SOLICITATION AMENDMENT MODIFICATION DE L'INVITATION

Title - Sujet Food Service Bldg Westmorland Inst	
Solicitation No. - N° de l'invitation EC016-141832/A	Amendment No. - N° modif. 004
Client Reference No. - N° de référence du client EC016-141832	Date 2014-01-17
GETS Reference No. - N° de référence de SEAG PW-\$PWB-020-3350	
File No. - N° de dossier PWB-3-36100 (020)	CCC No./N° CCC - FMS No./N° VME
Solicitation Closes - L'invitation prend fin at - à 02:00 PM on - le 2014-01-23	Time Zone Fuseau horaire Atlantic Standard Time AST
F.O.B. - F.A.B. Plant-Usine: <input type="checkbox"/> Destination: <input type="checkbox"/> Other-Autre: <input type="checkbox"/>	
Address Enquiries to: - Adresser toutes questions à: Donovan, Janine PWB	Buyer Id - Id de l'acheteur pwb020
Telephone No. - N° de téléphone (506) 636-5347 ()	FAX No. - N° de FAX (506) 636-4376
Destination - of Goods, Services, and Construction: Destination - des biens, services et construction:

Addenda numéro 4

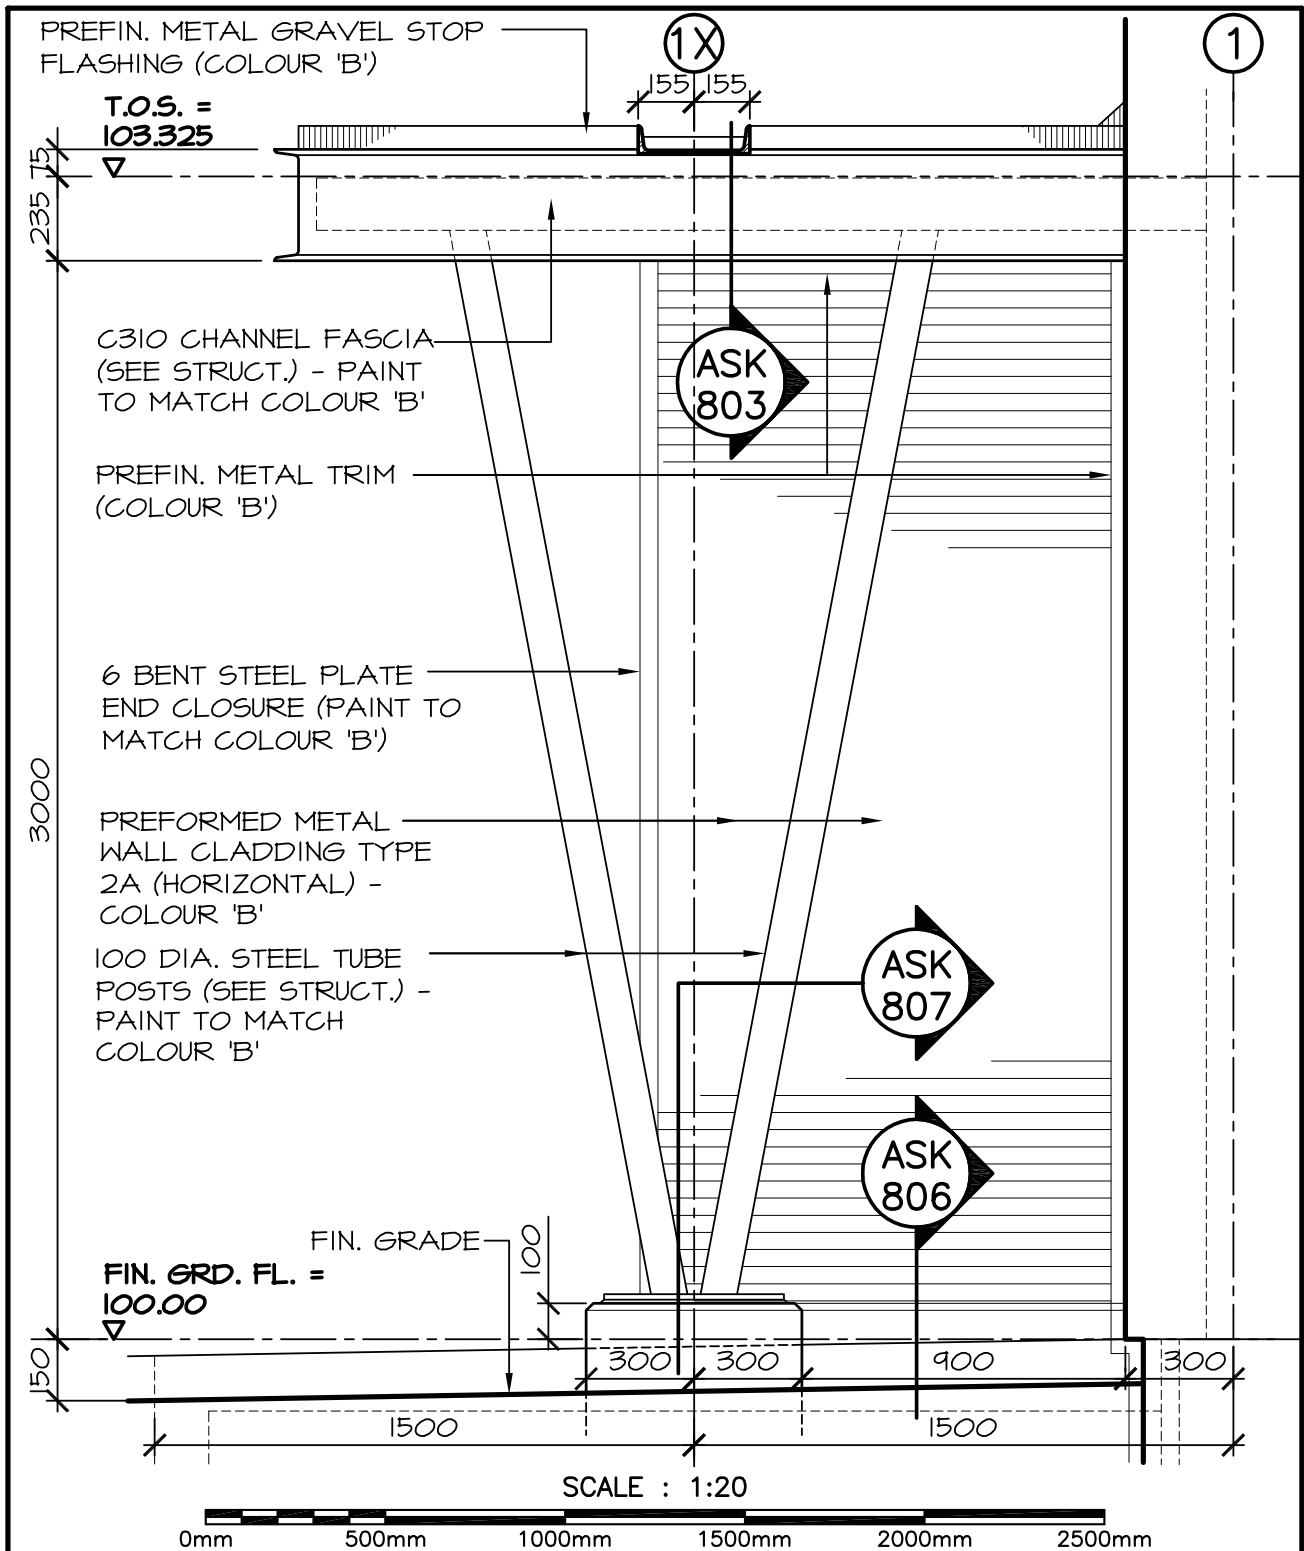
13. In reference to detail drawing 1/A8.3, please provide details for the wind break/screen at the canopy.

Answer: *This feature is detailed as part of the entrance canopy, details of which are included with this Addendum.*
